LAKESHORE PARK BUILDING JSP17-43

Consideration at the request of NSA Architects, Engineering, Planners for approval of Preliminary Site Plan and Stormwater Management Plan. The subject property is located in Section 3 west of Old Novi Road and south of South Lake Drive and is zoned R-4, One Family Residential. The applicant is proposing an update to Lakeshore Park in the City of Novi including an approximately 9,400 square foot community center, 129 parking spaces, one pavilion, and a bike lane to connect to the mountain biking trails.

MOTION SHEET

ORIGINAL ISSUE DATE: JUNE 30, 2017
PEA JOB NO: 2016-308
SCALE: 1" = 30'
DRAWING NUMBER: C-3.2

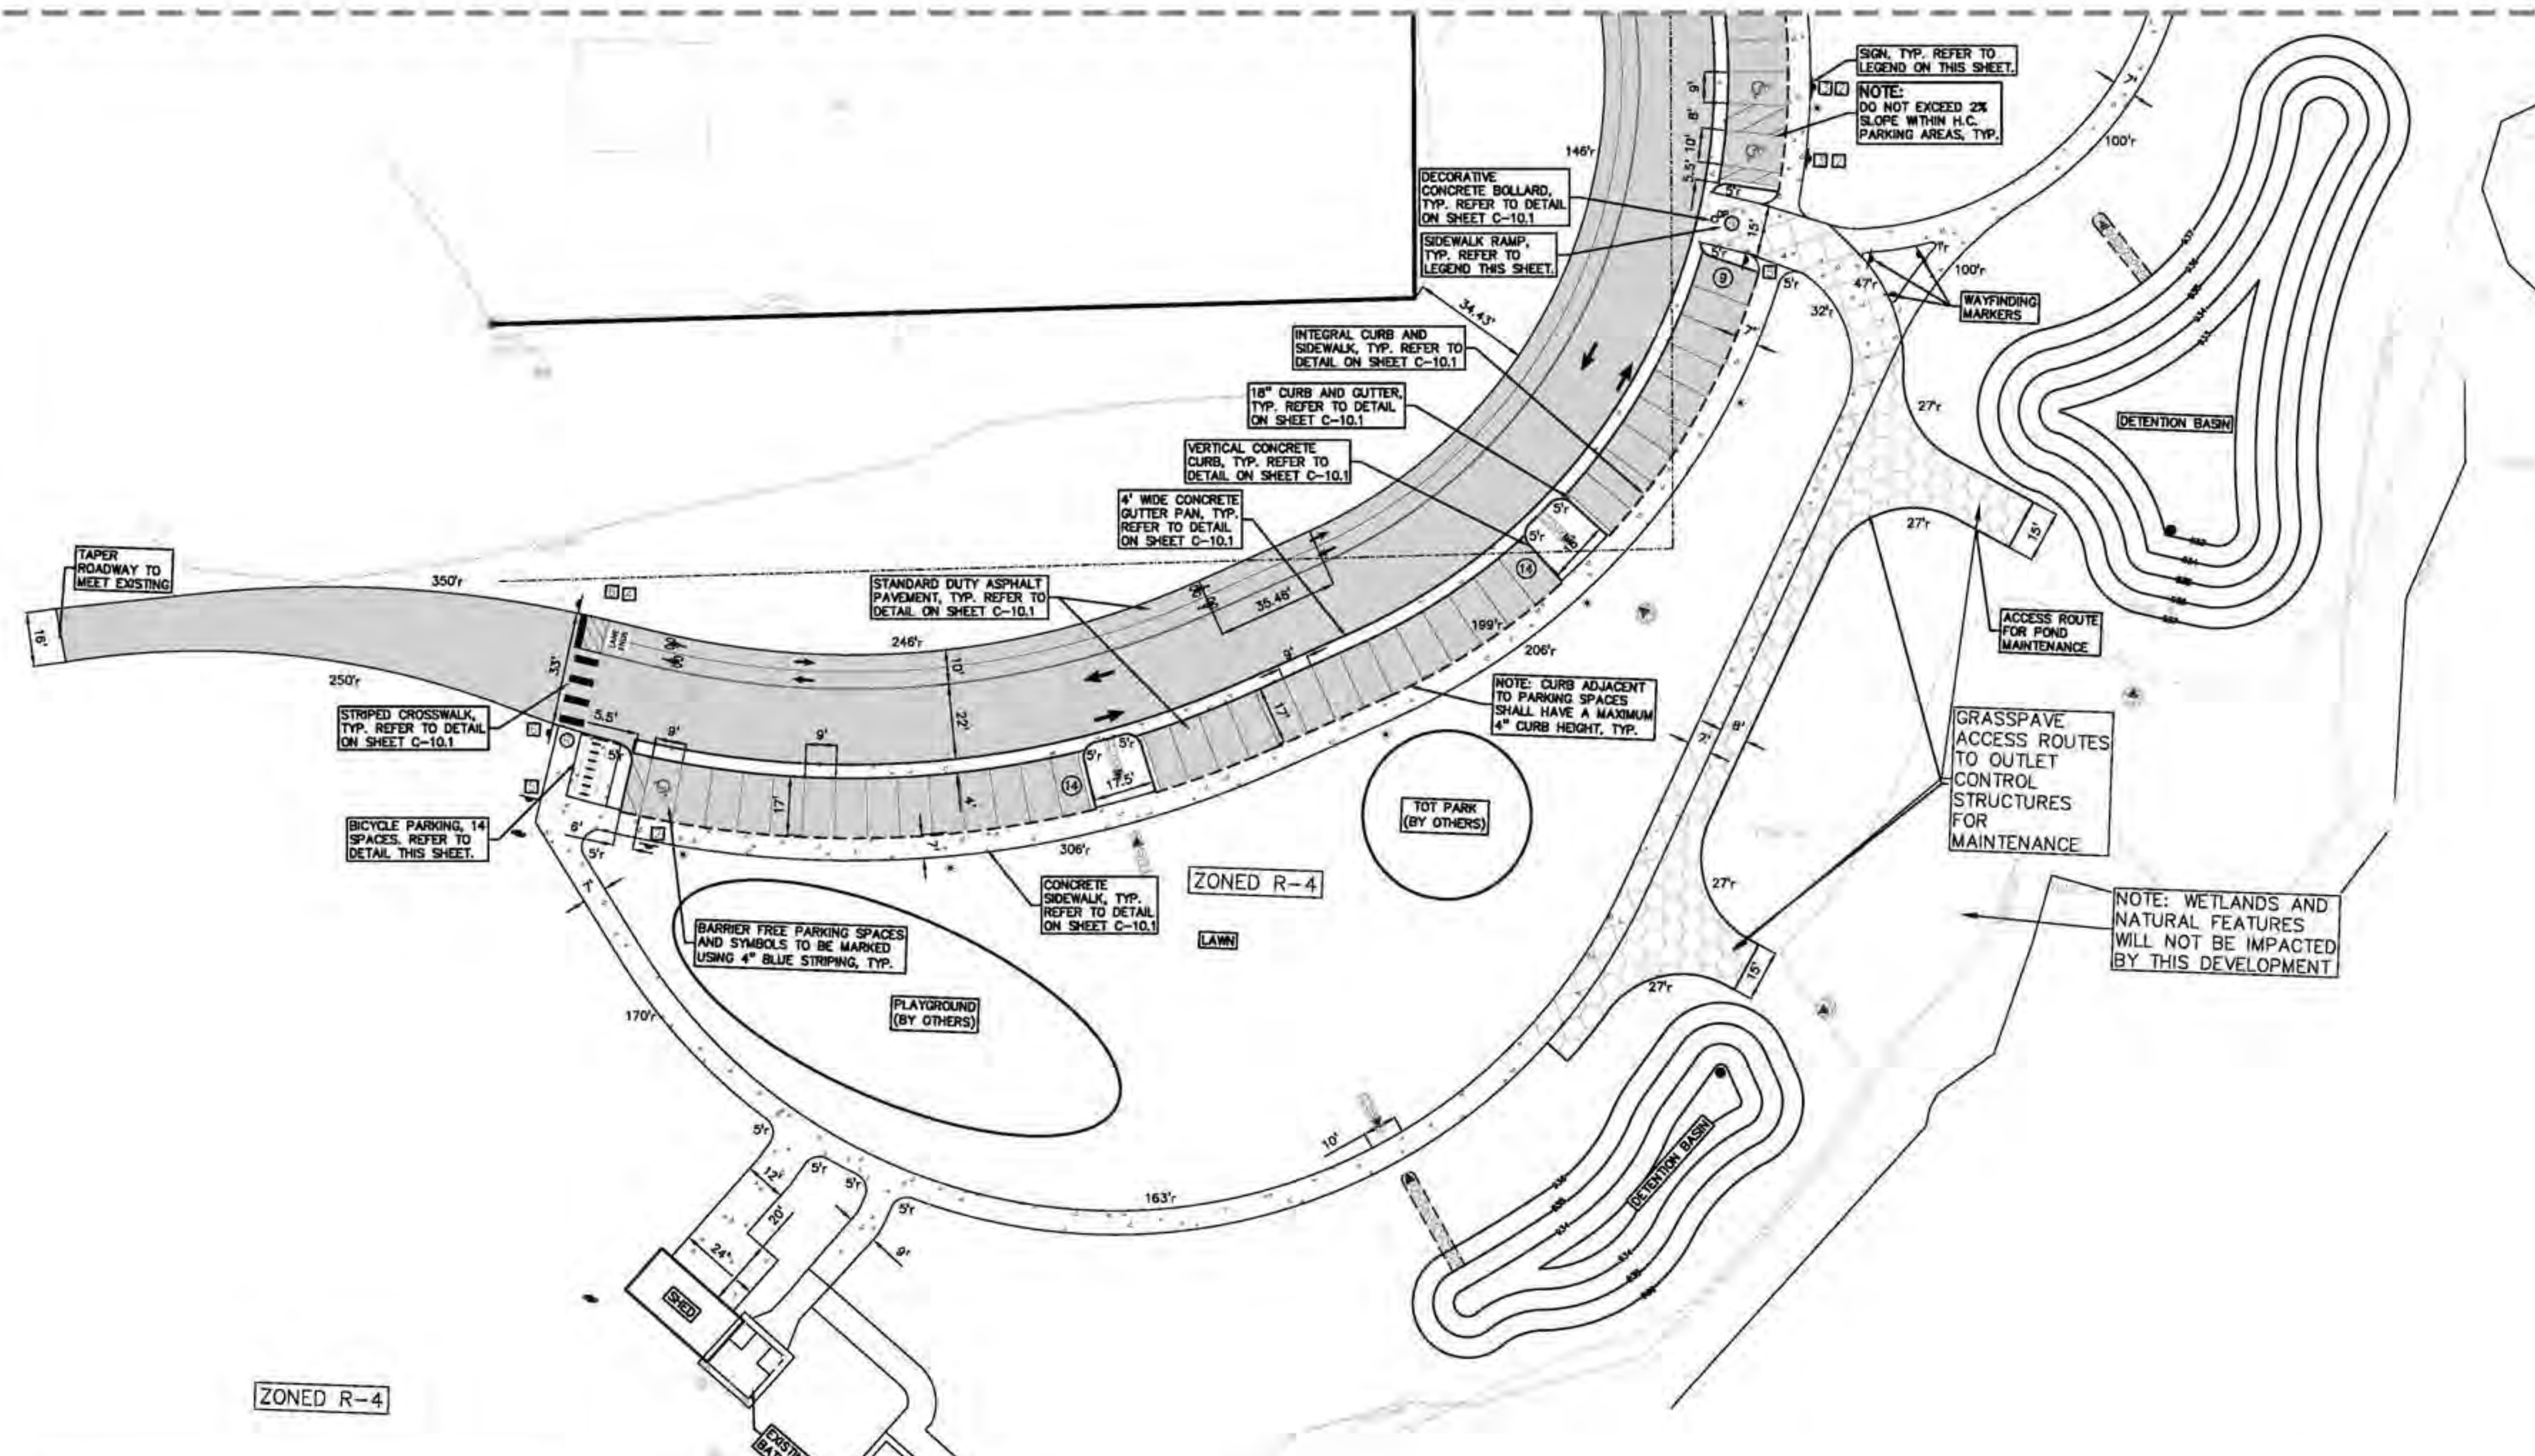
Response: Detail on sheet C-3.2 will be updated accordingly.

Response: Crosswalk warning signs will be relocated on sheet C-3.2.

ORIGINAL ISSUE DATE: JUNE 30, 2017
PEA JOB NO: 2016-308
SCALE: 1" = 30'
DRAWING NUMBER: C-5.2

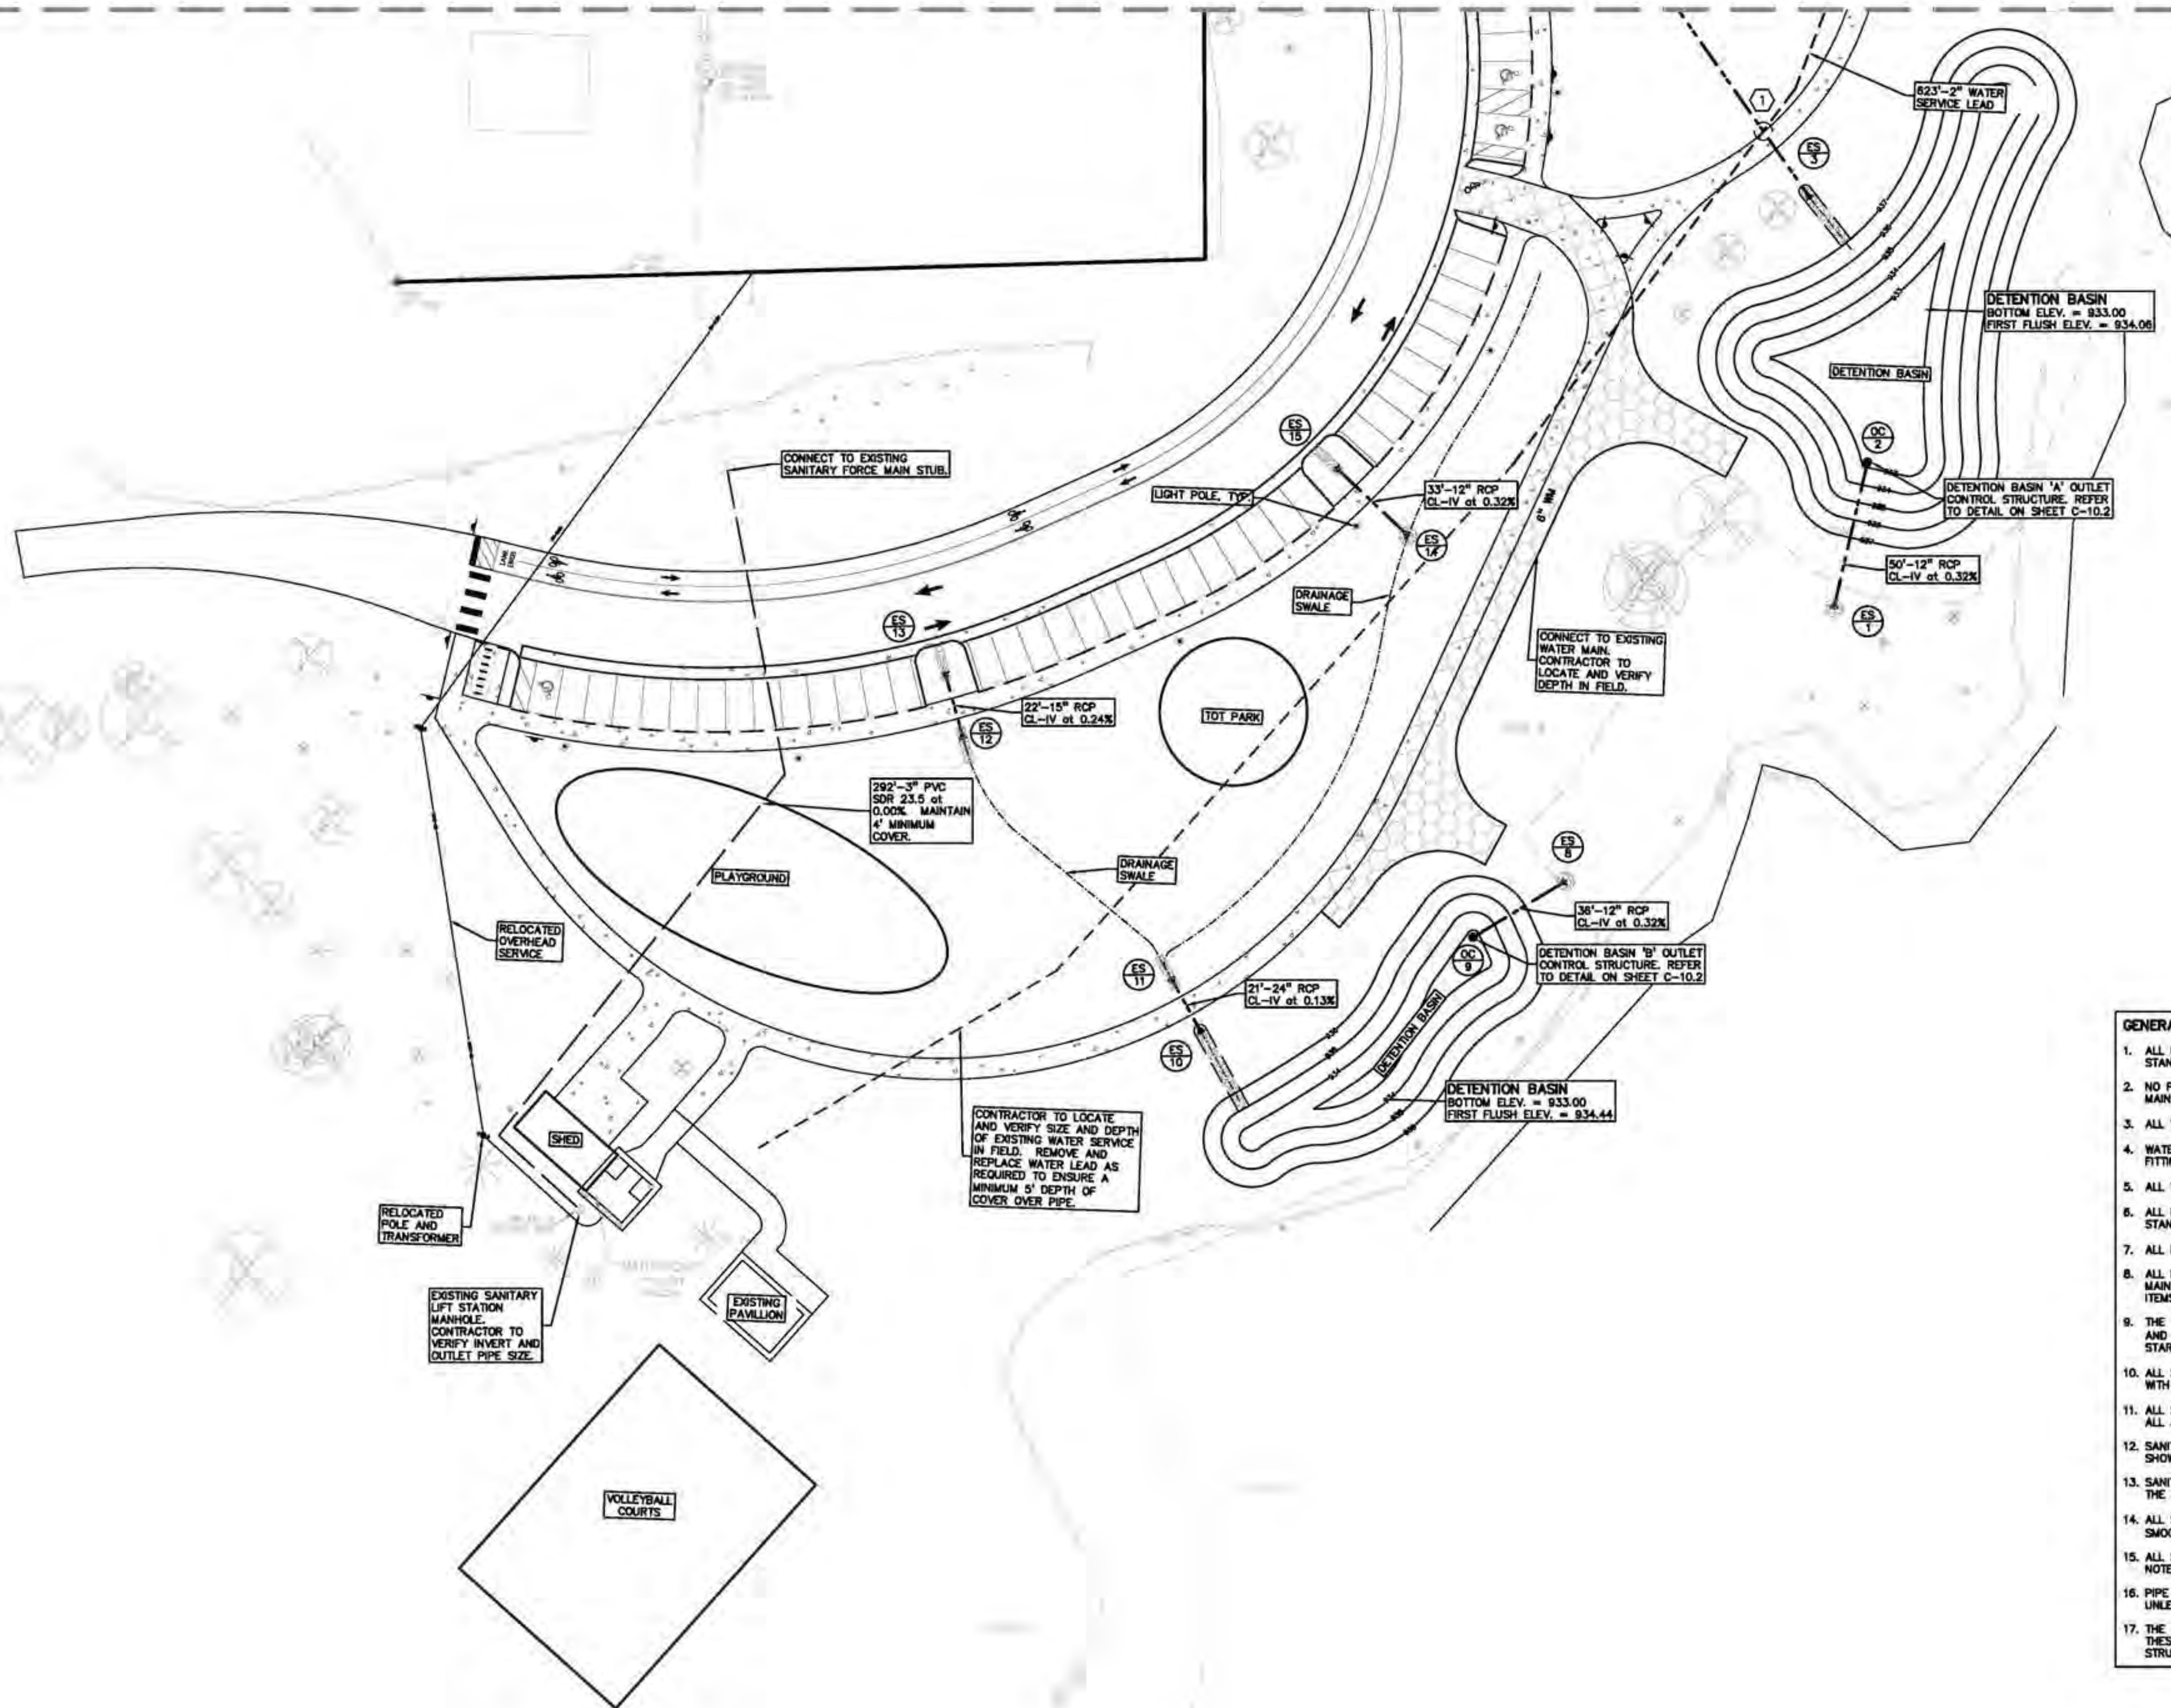
6. Provide clarification on sheet C5.2 on the intent and extent of water service lead replacement and delete any extraneous notes for water main. Show how existing water service will connect to proposed water main.

Response: Coordination will be performed with Water and Sewer to identify existing force main size. Sheet C-5.2 will be revised to match the existing size and material.

Response: Pond overflow spillways will be shown on sheets C-4.2 and C-5.2.

Response: Standpipe aggregate and stone access bridges will be shown on sheet C-5.2.

Response: Drawing will be revised on sheet C-5.1 and C-5.2 to comply with requirements.
